Product Change Notice (PCN)

PCN Number: **PCN-0451185R-01**

Product(s) Affected: PJ-050B

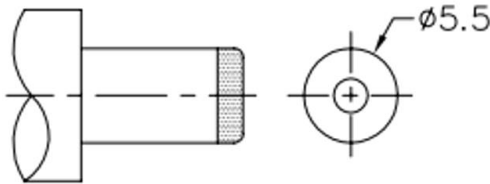
Description of Change: *Mechanical, electrical, and material changes as shown below:*

MATERIAL	PLATING
center pin	copper	nickel
terminal 1	brass	tin
terminal 2	copper alloy	tin
terminal 3	brass	tin
plastic	PBT

DESCRIPTION	MATERIAL	PLATING/COLOR
center pin	copper alloy (H65)	nickel
terminal 1	C2680 t=0.35	nickel-silver
terminal 2	C5210 t=0.25	nickel-silver
terminal 3	C2680 t=0.30	nickel-silver
cover	PA9T UL94V-0	black
housing	PA9T UL94V-0	black

MATING PLUG
Jack Insertion Depth: 8.5 mm

MATING PLUG
Jack Insertion Depth: 9.6 mm

Operating temperature range changing to -25C ~ +85C
